# Access Compliance Report

## Public Rights-of-Way

### (Curb Ramps)

Intersection ID: 10020108	Main Street: ASHLEY_RD	Cross Street: N/A	Location: W
ADA ID: 04EB8FBB4E69	Ramp Type: BlendTrans1	Initial Pass/Fail: Fail	Overall Compliance: No
			Severity Score: 10

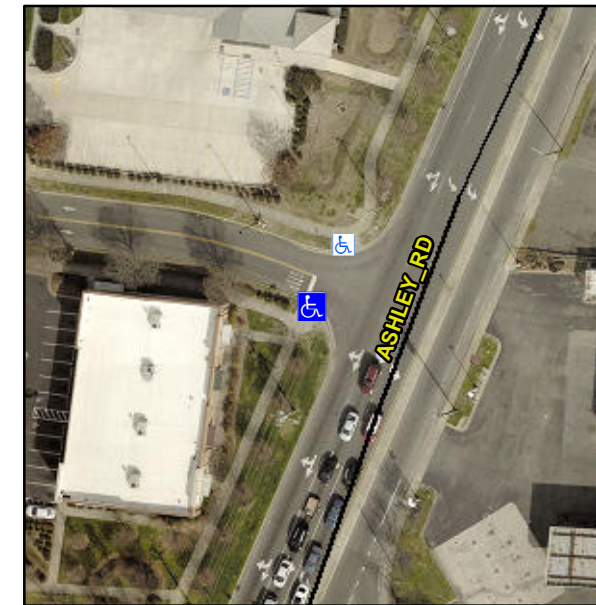
**Not Found, R304.5.1, R304.5.3**

Compliance	Description	Data	Compliance	Description	Data
N/A	Ramp Length (in)	121.0	Yes	BlendTrans Slope (%)	3.3
No	Ramp Width (in)	43.0	No	BlendTrans XSlope (%)	4.9
N/A	Flare Type LT	N/A	N/A	Flare Type RT	N/A
N/A	Flare Slope LT (%)	N/A	N/A	Flare Slope RT (%)	N/A
N/A	Flare Traversable LT?	N/A	N/A	Flare Traversable RT?	N/A
N/A	Landing Length (in)	N/A	N/A	DWS Provided?	N/A
N/A	Landing Width (in)	N/A	N/A	DWS Contrast?	N/A
N/A	Landing Slope (%)	N/A	N/A	DWS Length (in)	N/A
N/A	Landing X Slope (%)	N/A	N/A	DWS Full Width?	N/A
N/A	Landing Curb? (Y/N)	N/A	N/A	DWS Offset (in)	N/A
N/A	Shared Landing?	N/A			
N/A	Gutter Ponding?	N/A	N/A	Gutter Slope (%)	N/A
N/A	Gutter Lip Ht (in)	N/A	N/A	Gutter X Slope (%)	N/A
N/A	Painted X Walk1?	No	N/A	Painted X Walk2?	N/A
	X Walk 1 Direction	To NE		X Walk 2 Direction	N/A
	X Walk 1 Width (in)	N/A		X Walk 2 Width (in)	N/A
	X Walk 1 Slope (%)	0.2		X Walk 2 Slope (%)	N/A
	X Walk 1 X Slope (%)	4.9		X Walk 2 X Slope (%)	N/A

N/A	Ramp inside XWalk1?	N/A	N/A	Ramp inside XWalk2?	N/A
	Road Slope (%)	4.9		Clear Space?	N/A
	Road X Slope (%)	0.2	N/A	Clear Space to XWalk (in)	N/A
N/A	Any Obstructions?	N/A	N/A	Storm Grate/Utility Hazard?	N/A
	Obstruction Type			Storm Grate/Utility Type	
		N/A			N/A
			Yes	Surface Condition? (G/P)	Good
			No	Curb Slope (%)	29.0

**Remove & Replace Curb Ramp With Two New Directional Ramps or Equivalent.**
